DIXIE-NARCO, INC. SERVICE BULLETIN #122

MODELS: All Slant Shelf Bottle/Can Venders

Subject: Installation Instructions - Temperature Control - Knob
Type Numbered.

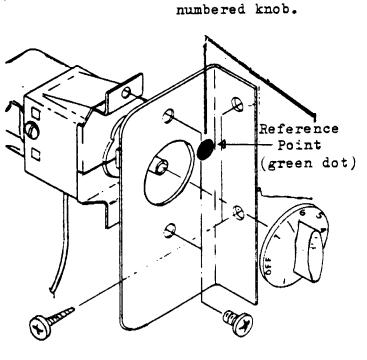
3. Install the temperature control on the mounting bracket (Ranco or Cutler Hammer) as shown <u>Fig. 1</u> or <u>Fig. 2</u> whichever is applicable.

4. To obtain a 33°F next to be vended can set the knob at neutral. Neutral is located 1/2 way of the
